TRANS/WP.29/2003/12  
12 December 2002

World Forum for Harmonization of Vehicle Regulations (WP.29)  
(One-hundred-and-twenty-ninth session,  
11-14 March 2003, agenda item 4.2.16.)

PROPOSAL FOR DRAFT SUPPLEMENT 3 TO REGULATION No. 112

(Headlamps emitting an asymmetrical passing beam)

"Annex 4 - Appendix 1

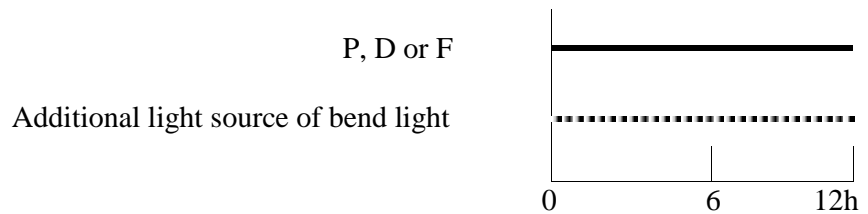
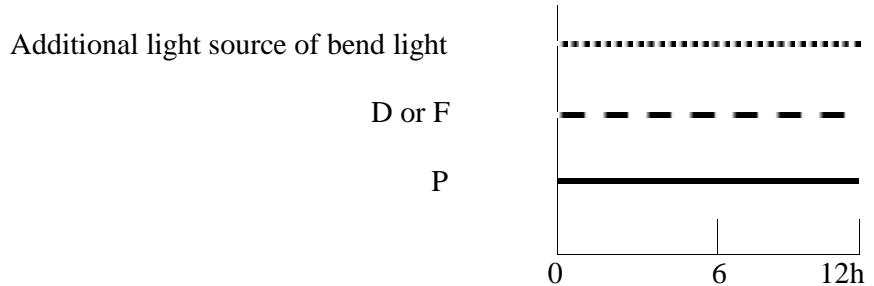
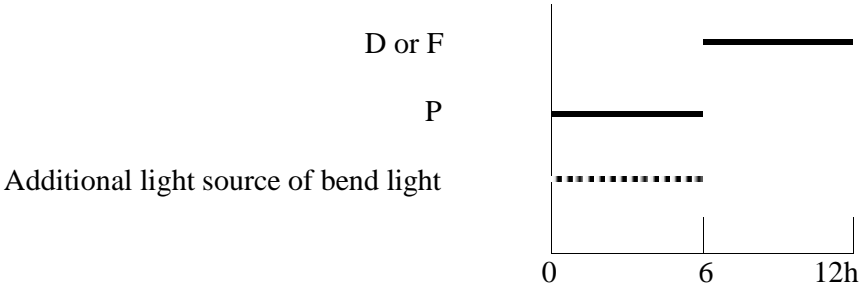
Annex 4, paragraph 1.1.1.1., add a new subparagraph (d) to read:

"(d) In the case of a passing beam designed to provide bend lighting with the addition of a light source, this light source shall be switched on for 1 minute, and switched off for 9 minutes during the activation of the passing beam only (see annex 4 - appendix 1)."

Insert new Annex 4 - appendix 1, to read:
